# UNITED STATES PATENT AND TRADEMARK OFFICE

APPLICATION NO.	FILING DATE	FIRST NAMED INVENTOR	ATTORNEY DOCKET NO.	CONFIRMATION NO.
09/748,616	12/22/2000	Robert Eugene Krautkramer	659/773	4594
757	7590	11/04/2004	EXAMINER	
BRINKS HOFER GILSON & LIONE P.O. BOX 10395 CHICAGO, IL 60610			PRONE, JASON D	
			ART UNIT	PAPER NUMBER
			3724	
DATE MAILED: 11/04/2004

# Office Action Summary

**DETAILED ACTION*****Drawings***

Fig. 4

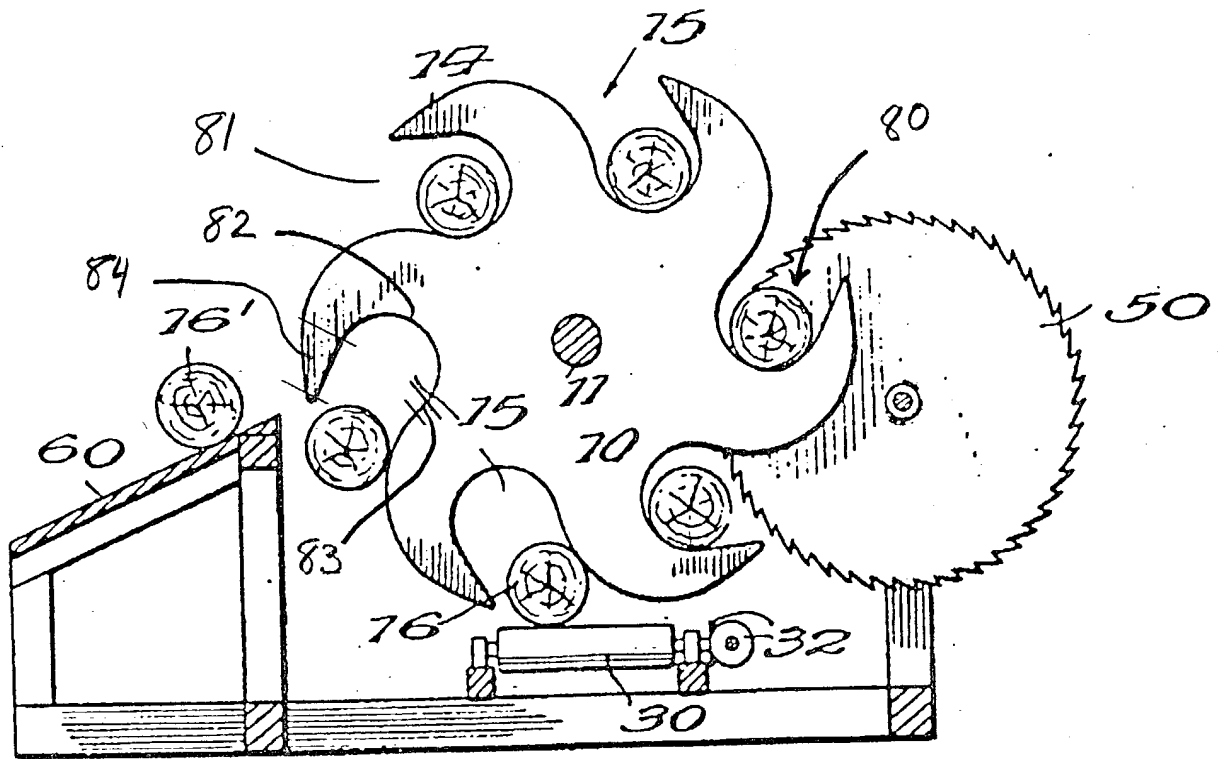
9. Claims 31-36 and 42 are rejected under 35 U.S.C. 102(b) as being anticipated by Wheless (see page 9 of this office action for examiner added clarifying reference numbers).

Wheless discloses the same invention including a cutting device (50), a pocket (15), that the pocket is configured to maintain the log in the pocket without the use of an external structure to hold the log in the pocket (80), that the pocket includes an open end (81), a closed end (82), a first planar surface (83 in between lines), a second planar

surface (84 in between lines), that the second planar surface is larger than the first planar surface (83 and 84), a concave surface between the planar surfaces that forms the closed end (82), a plurality of channels (Fig. 1), a sprocket (10) that support the pocket and rotates about an axis (11), that the distance between the first and second planar surfaces is greater than the diameter of the log (16), that the cutting device exerts a force on the log (Fig. 4), that the pocket counterbalances the forces (Fig. 4), that the first planar surface and the concave surface counterbalance the forces exerted on the log (Fig. 4), that the cutting device is configured to pass through the channels (Fig. 1), and that the sprocket supports a plurality of sprockets (Fig. 4).
